Reference: 0470861

Subject: Bonshaw Solar Farm (SSD 9438) Amendment Report

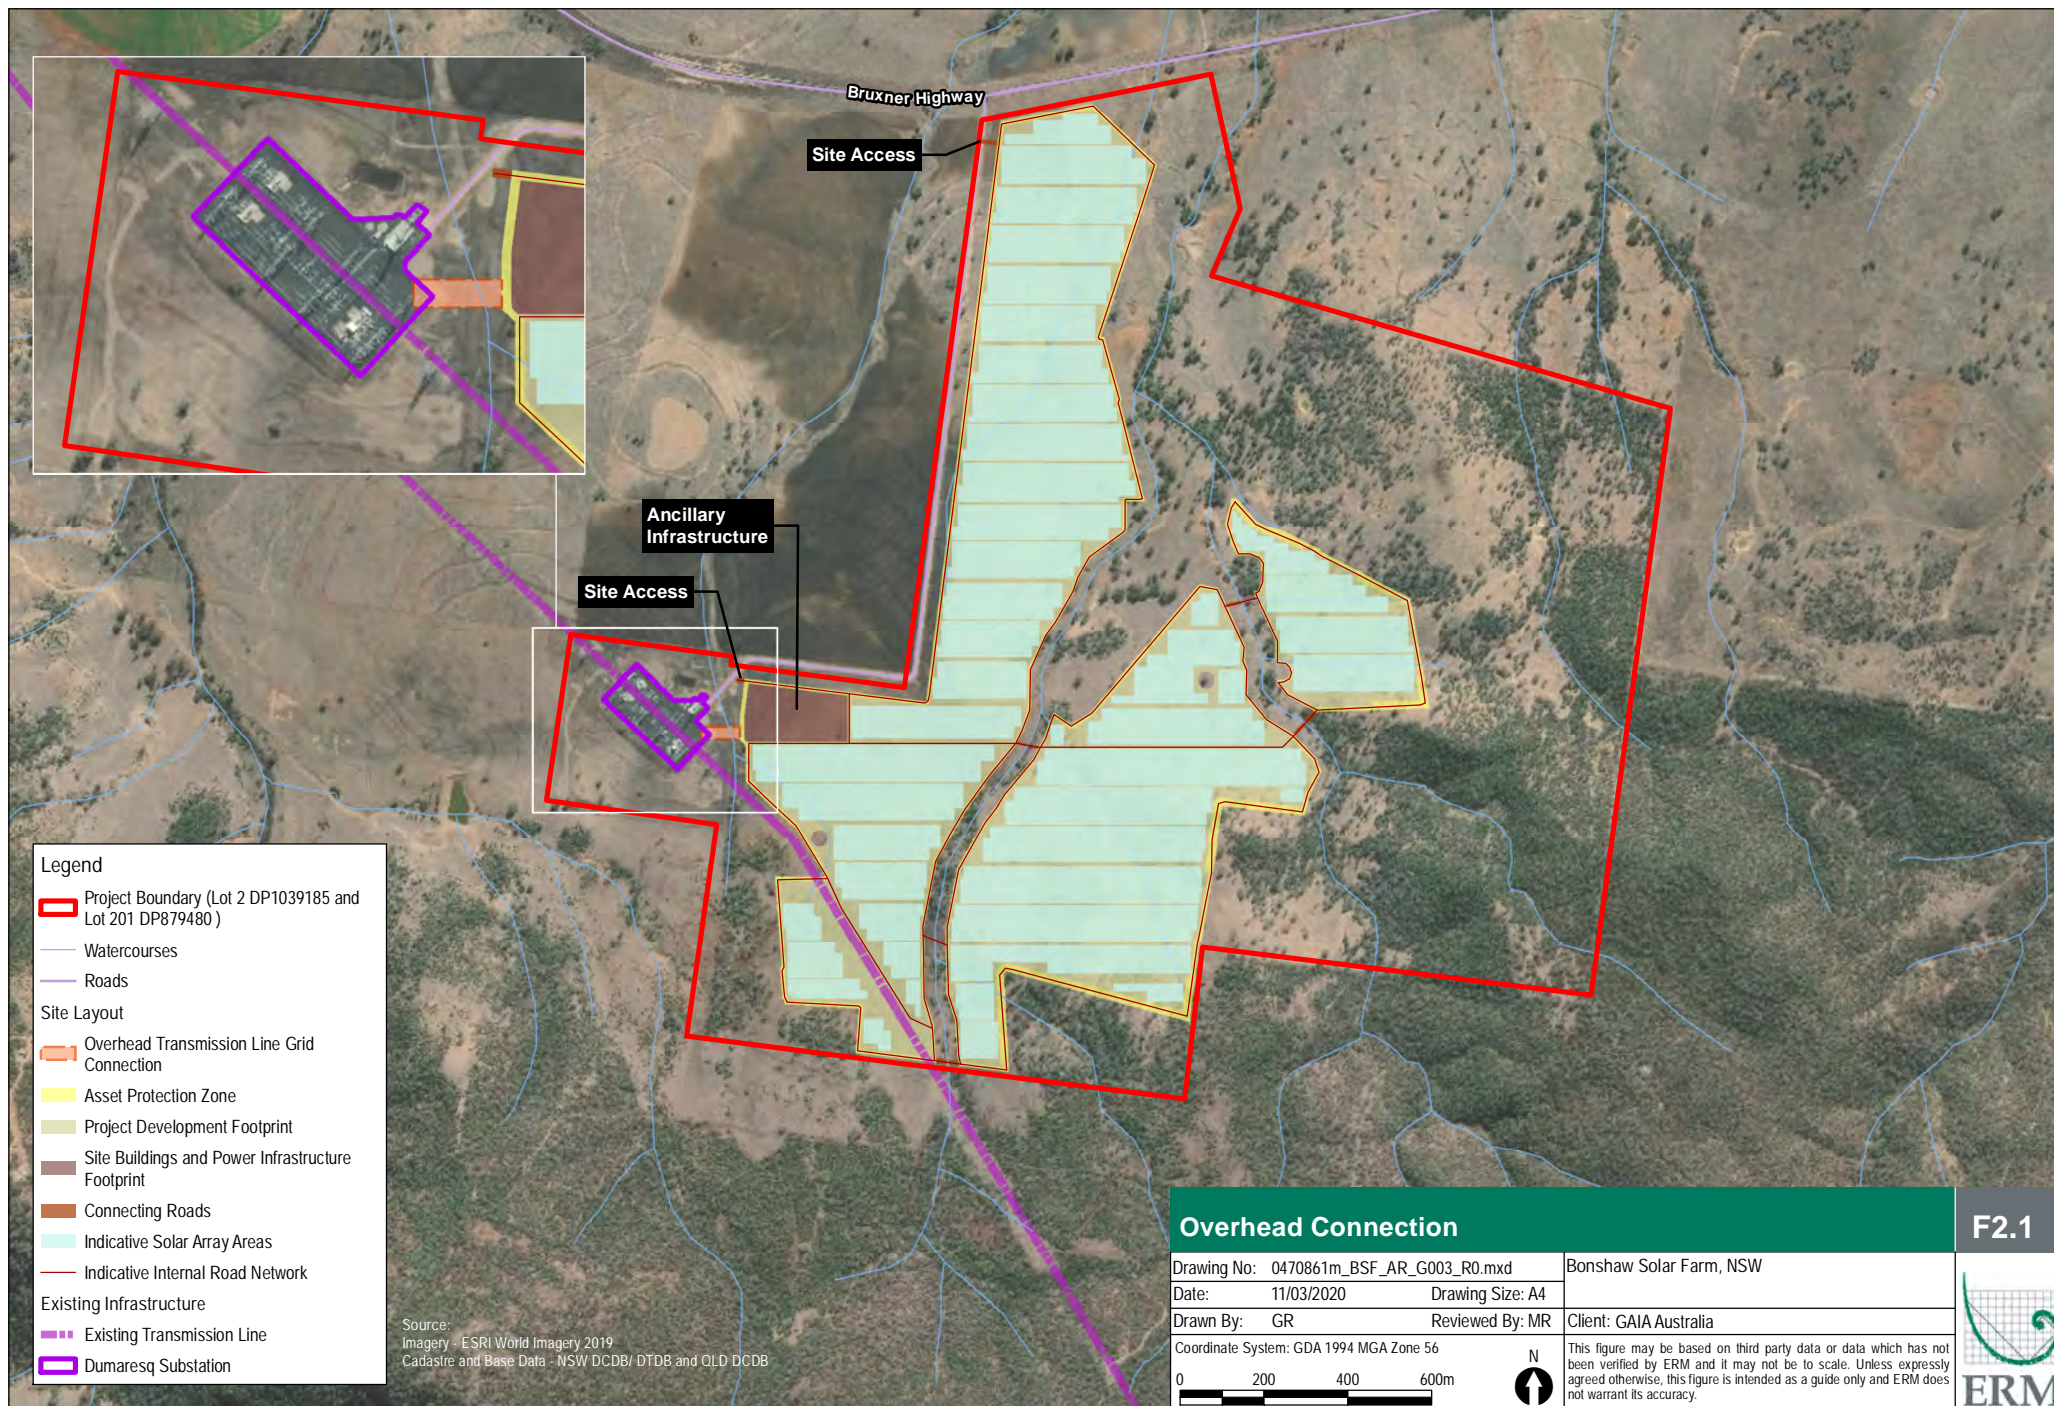
This amendment report provides the inclusion of the Dumaresq Substation for the Project, specifically addressing the environmental impacts associated with the overhead connection from the Bonshaw Solar Farm to the existing Dumaresq Substation. The overhead connection will include a 30 m easement that will require ongoing maintenance as a transmission easement.

The overhead connection will connect from a pylon in the 'Ancillary Infrastructure' area, extending approximately 150 m directly into the Dumaresq Substation. There will be no ground disturbance within the transmission corridor.

The location of the overhead connection and the easement area is shown in *Figure 2-1* below.

F2.1

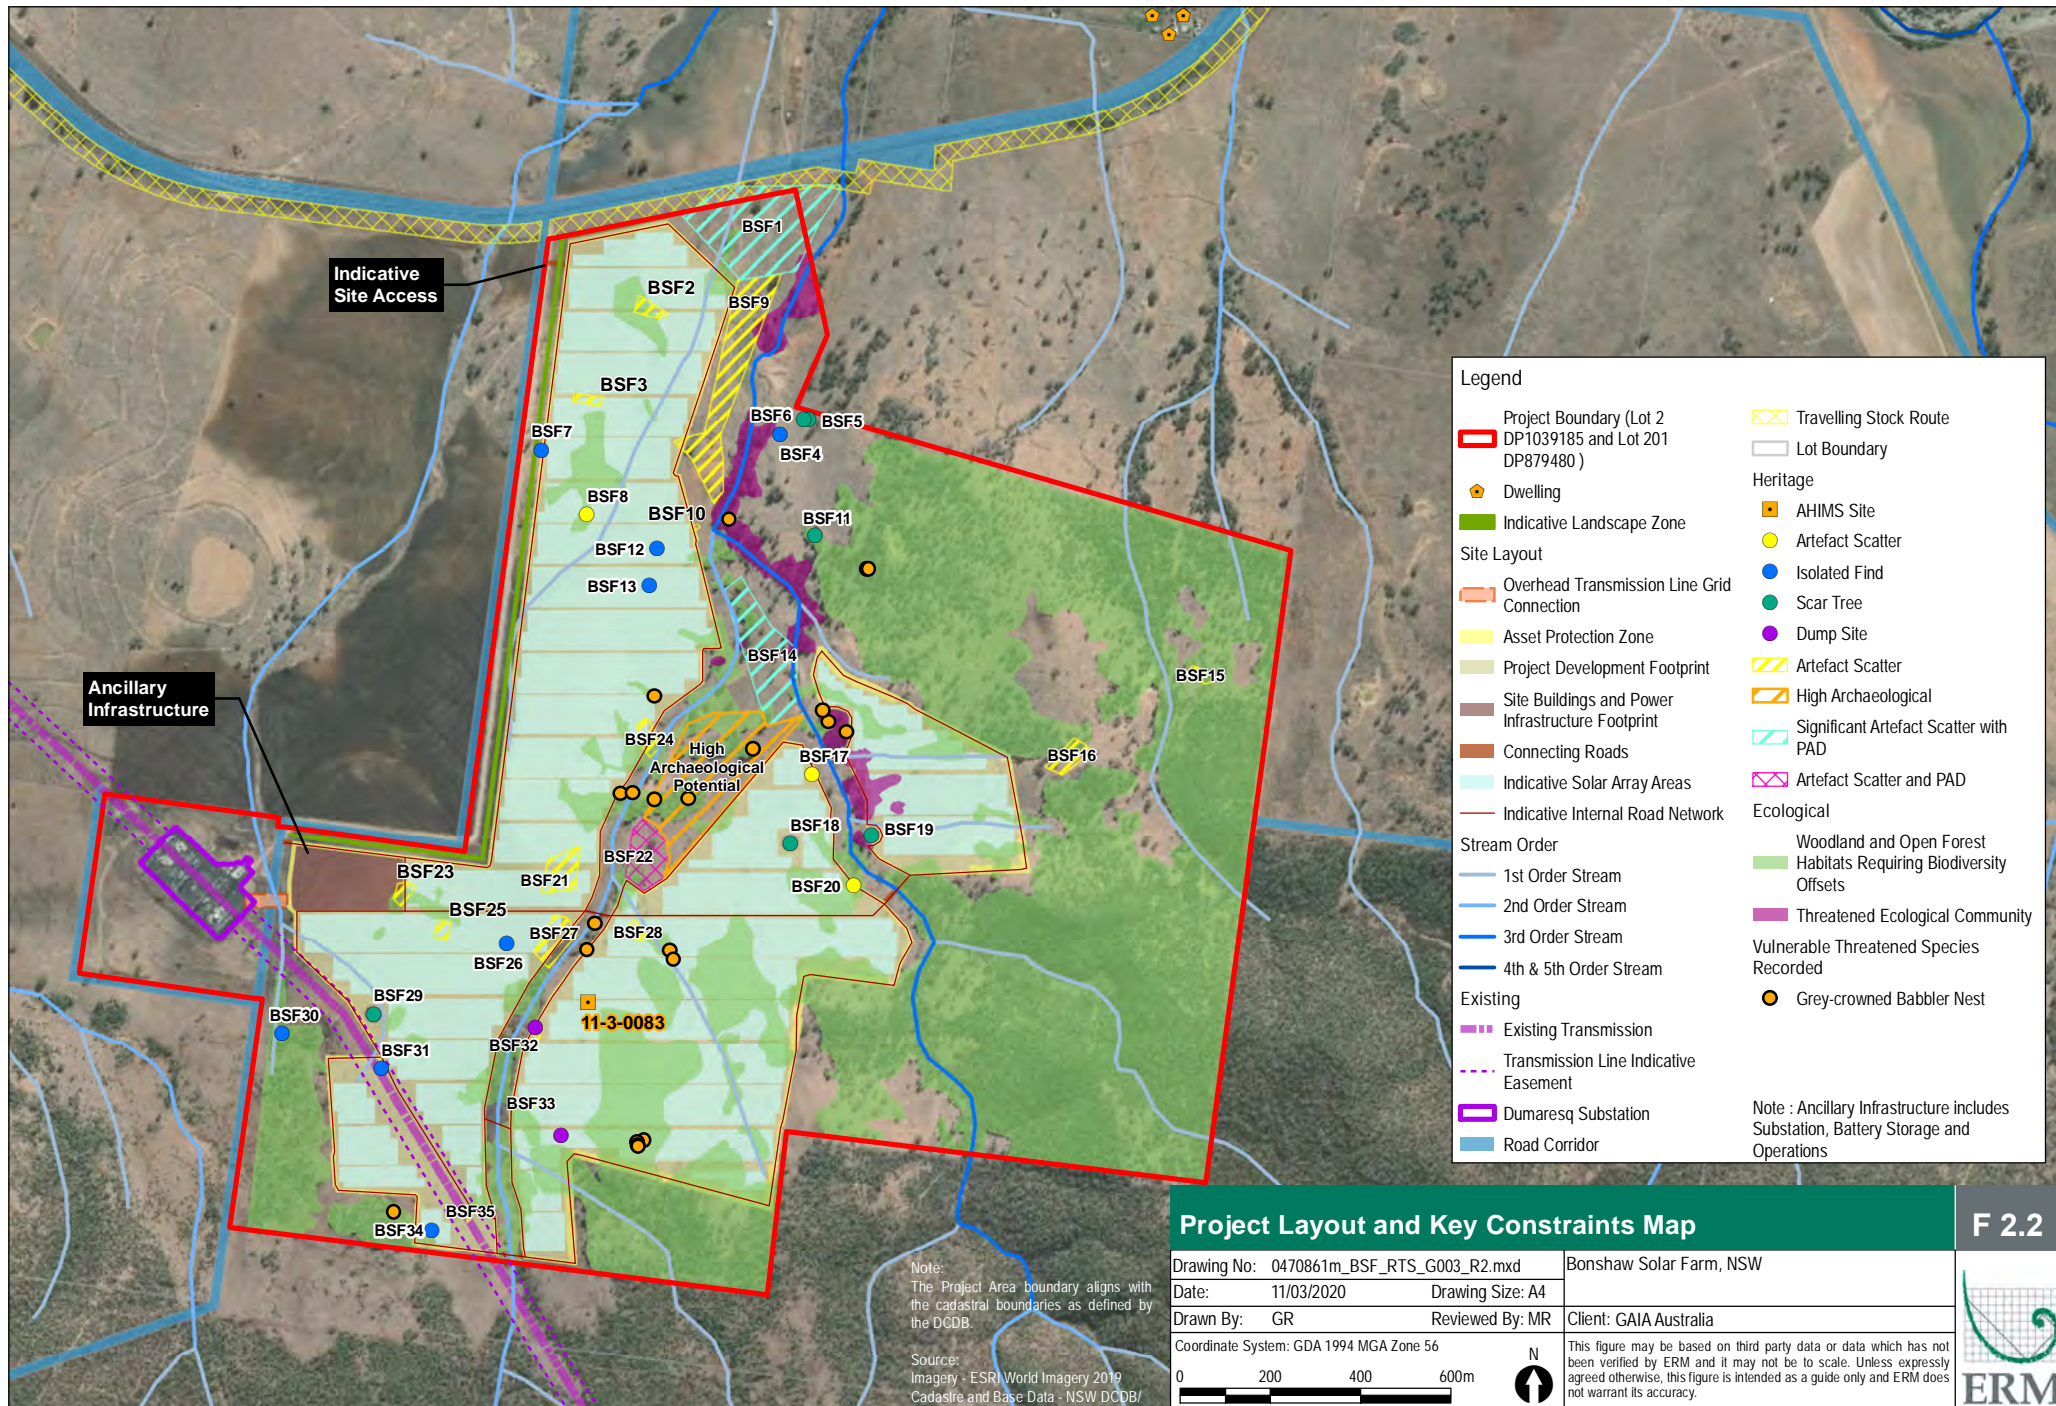
The implications of these updates to the project on the layout is provided in *Figure 2-2* below.
